RE: 1321 Flightway Ave SE
Grading and Drainage Plan
Engineer's Stamp Date: 03/10/2026
Hydrology File: M15D056A
Case # HYDR-2026-00090

Based upon the information provided in your submittal received 03/10/2026, the Grading and Drainage Plan **is not approved** for Grading Permit and Building Permit. The following comments need to be addressed for approval of the above referenced project.

GD-1

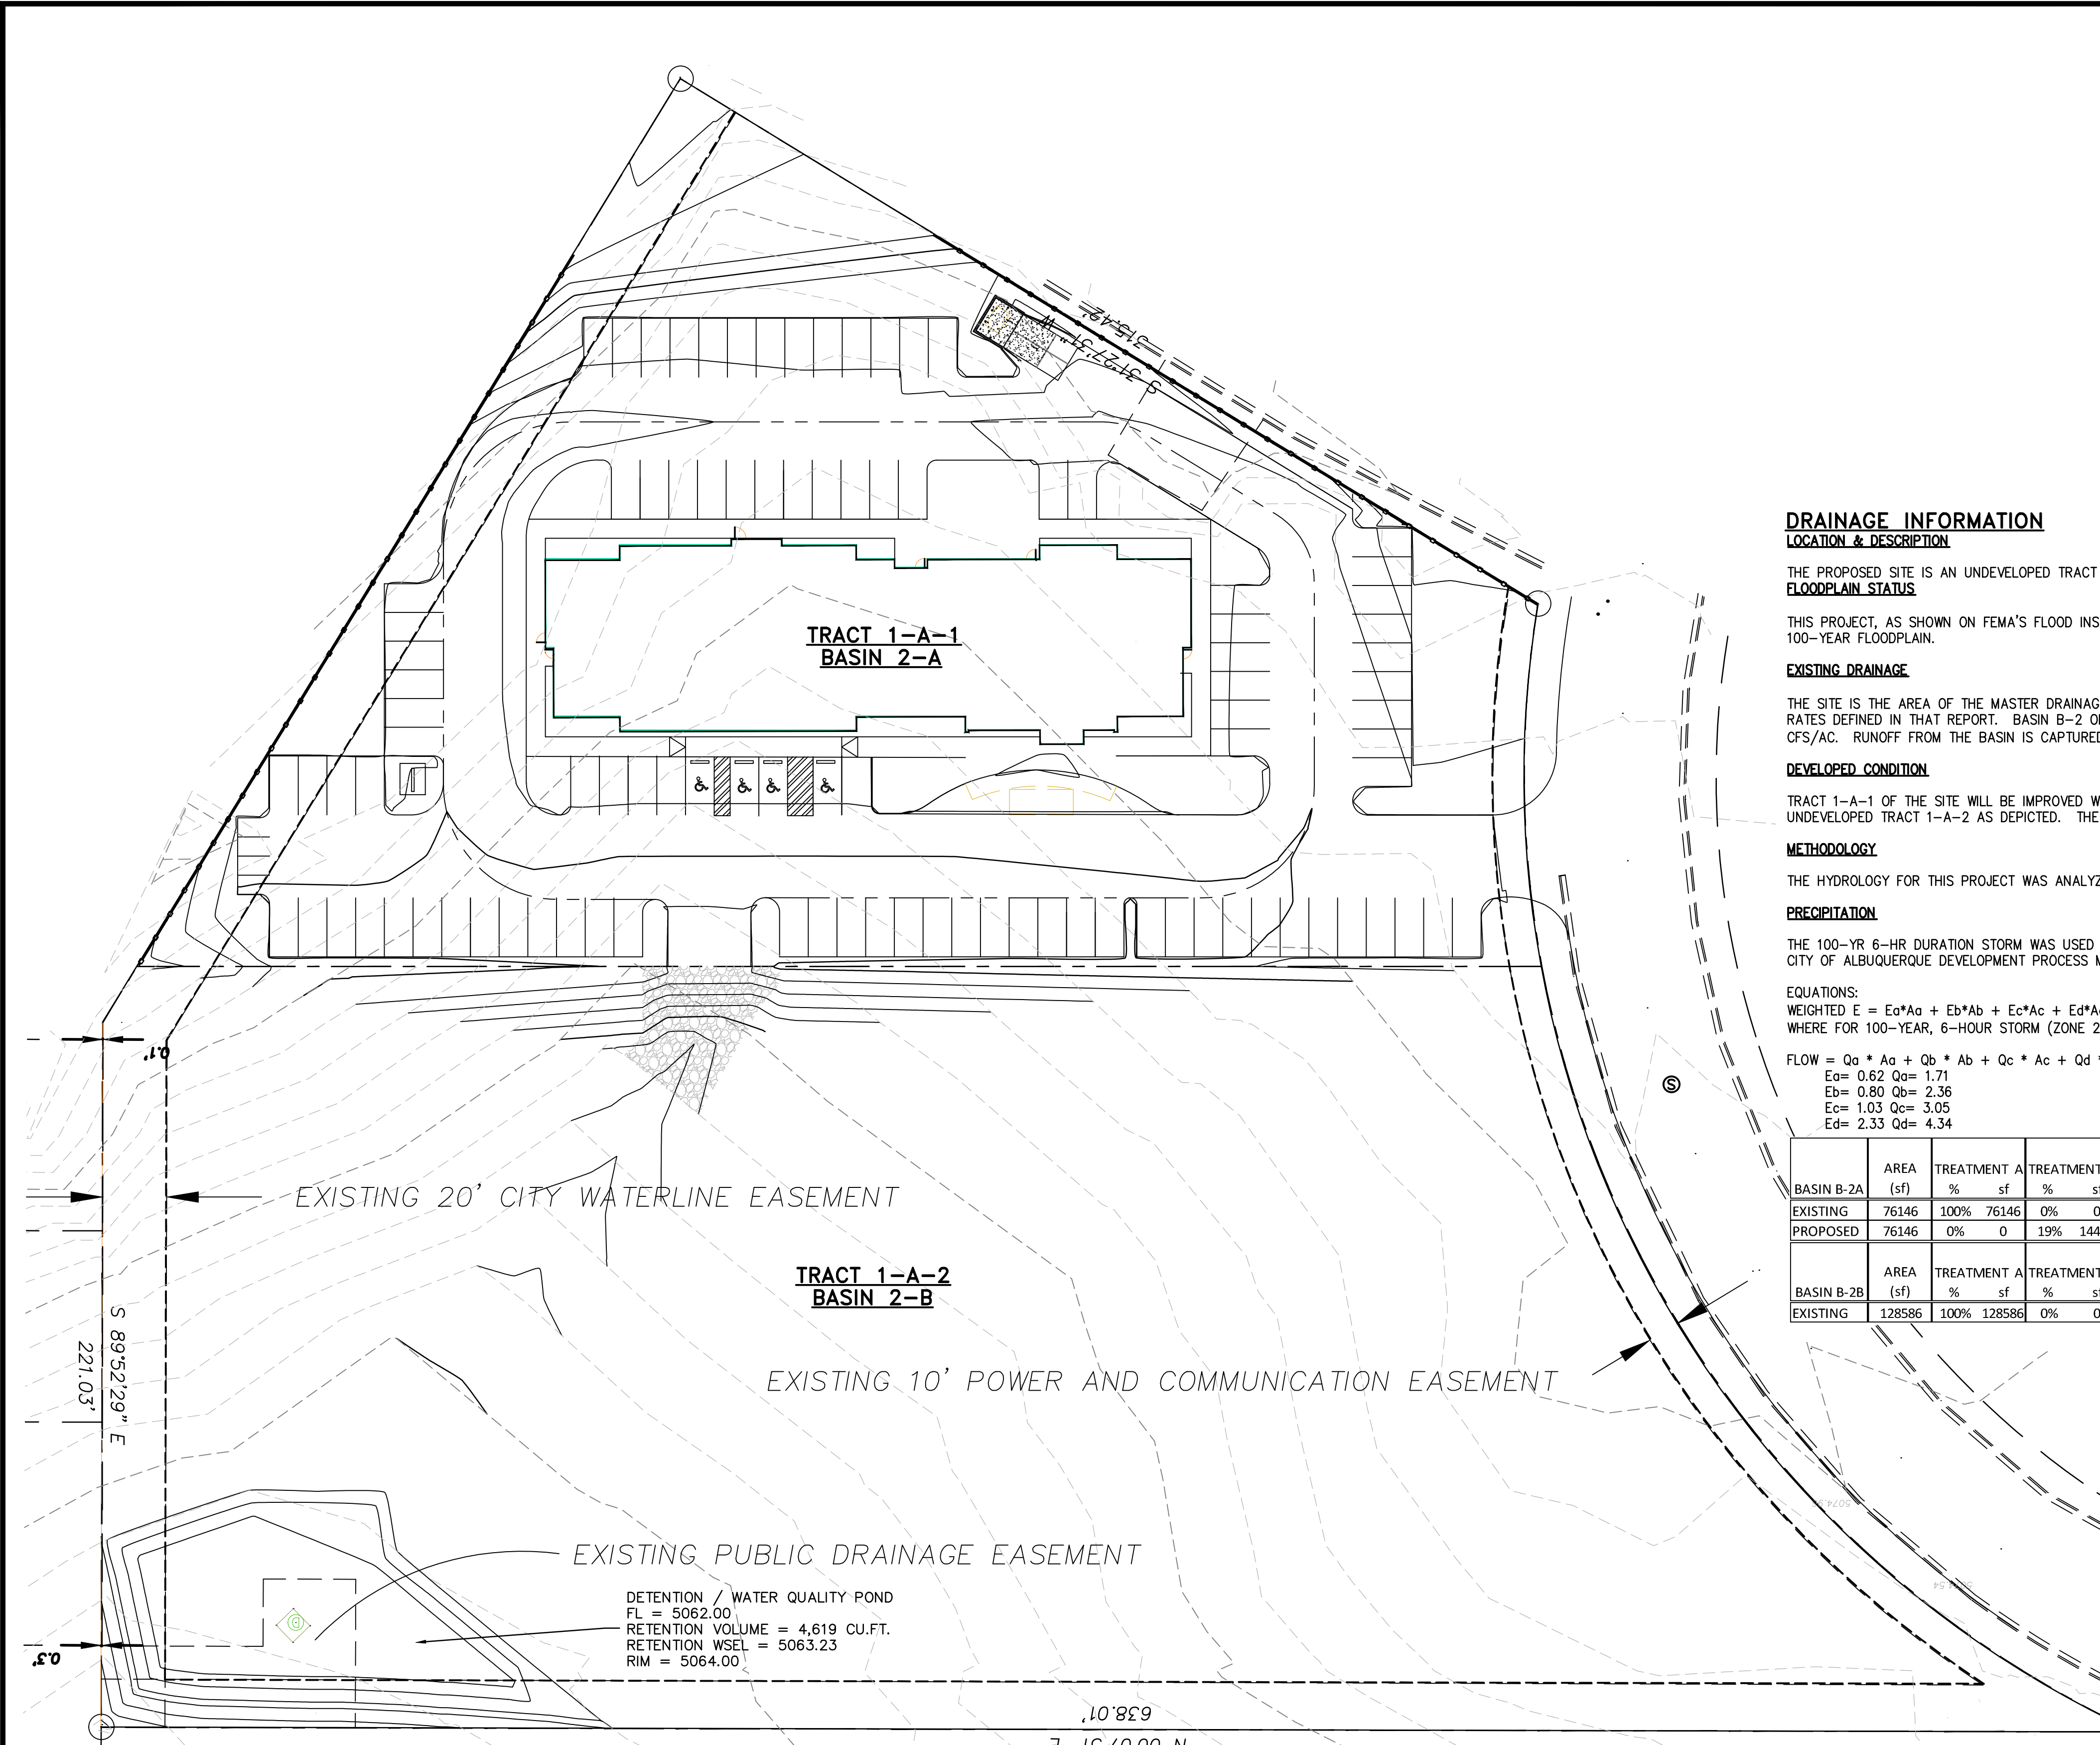
1. Show Finished Pad Elevation.

2. Per the IDO, the property owner of the property is responsible for building the adjacent half of Flightway Ave to include curb & gutter, and sidewalk. The project will have to go to the Development Facilitation Team (DFT) for approval of the Infrastructure List.
3. Include project benchmark and datum.
4. Add to General Notes #4 (Both Sheets) - "Side slopes need to be stabilized with Native Grass Seed (per City Spec 1012) with Aggregate Mulch or equal (Must satisfy the "Final Stabilization criteria" CGP 2.2.14.b.)".
5. Please number the ponds and include a label on each with the SWQV and elevation, the 100-year volume and elevation, the peak 100 year inflow and outflow, the spillway crest elevation, the spillway flow depth, and the dam top elevation.
